TO: Mayor Andre Dickens, City of Atlanta
ATTN TO: Monique Forte, Planner III, City of Atlanta
FROM: Mike Alexander, Director, ARC Center for Livable Communities
RE: Development of Regional Impact (DRI) Review

Name of Proposal: Forge Atlanta DRI 3533

Description: A DRI review of a proposal to construct a large-scale mixed-use development in the southwest area of downtown in the City of Atlanta. The approximately 10-acre site is bounded by Packard Street, Ted Turner Drive, Whitehall Street, and a rail line and is currently occupied by small-scale industrial and multi-family residential buildings and parking lots. Specifically, the project proposes 1,500 multi-family residential units, a 260-room hotel and conference center, 50,000 SF of cultural activity space, 1,750,000 SF of office space, and 69,000 SF of retail space. The project is adjacent to the Garnett MARTA station and multiple transit bus stops. Associated sidewalk and bicycle improvements are planned. .

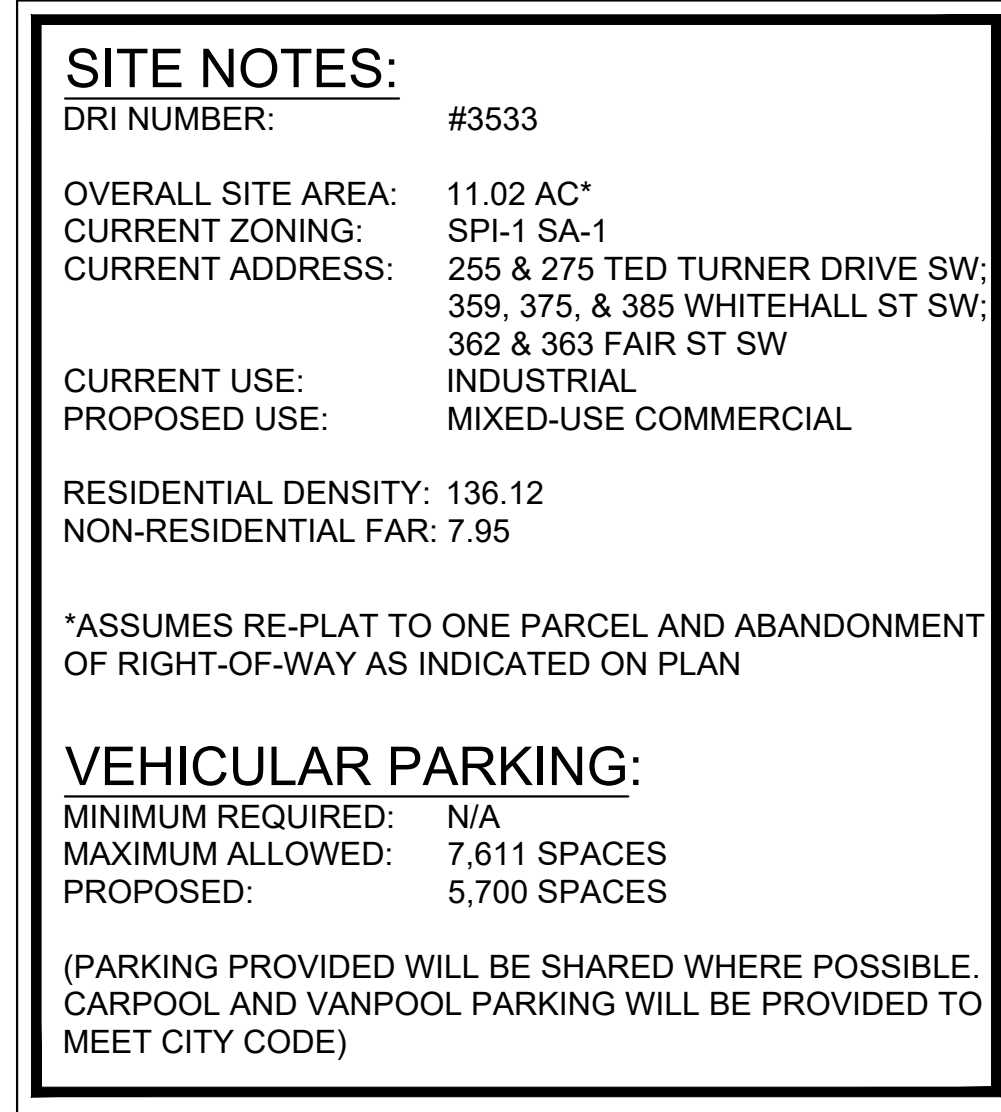
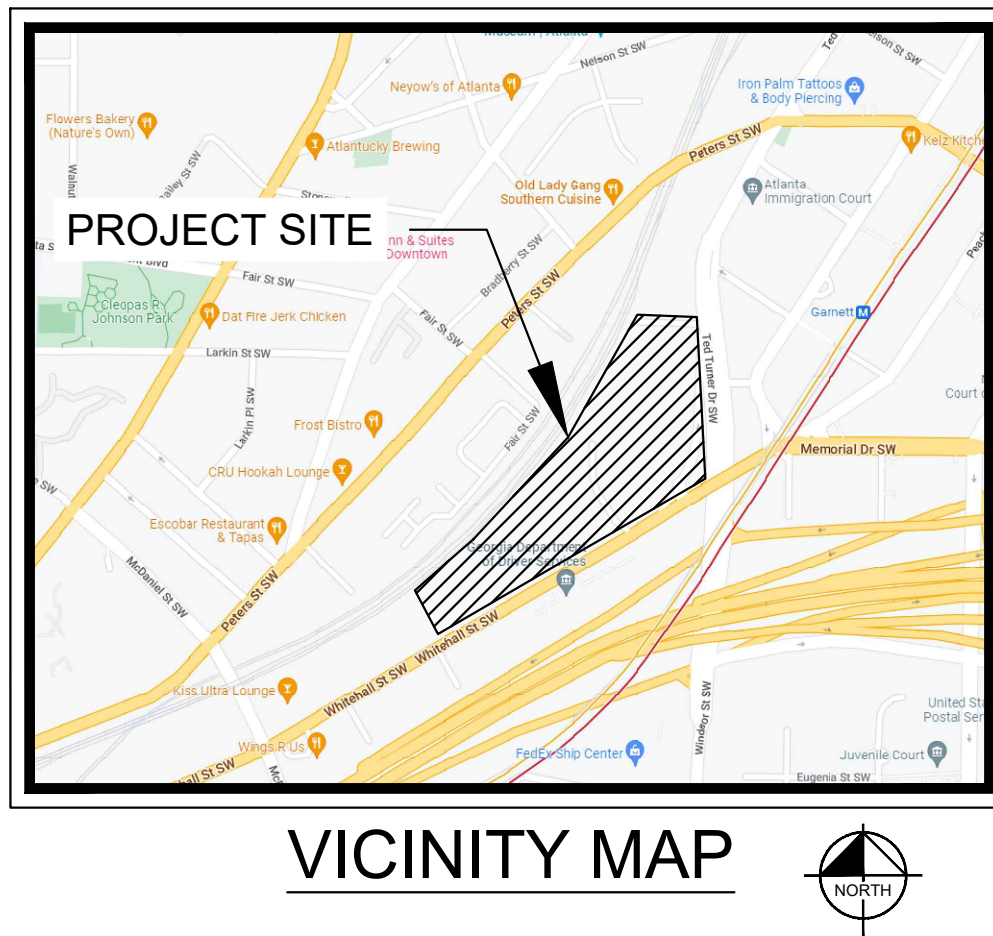
part of the project to the south. The proposed deceleration/turn lane and associated barrier shown on the site plan at Ted Turner Drive and Castleberry Street will disrupt the pedestrian flow along Ted Turner and is not in keeping with the need to prioritize pedestrian access over vehicular access in this core downtown location. The site plan does not show a sidewalk along Ted Turner at this location.

The three driveways proposed on Whitehall Street are fairly close together and will disrupt the bike and pedestrian flow in that location. A reduction to two driveways would be supportive of creating a safer and more inviting biking and walking environment.

The site plan illustrates a proposed pedestrian bridge to connect to Castelberry Hill but the implementation would need railroad approval.
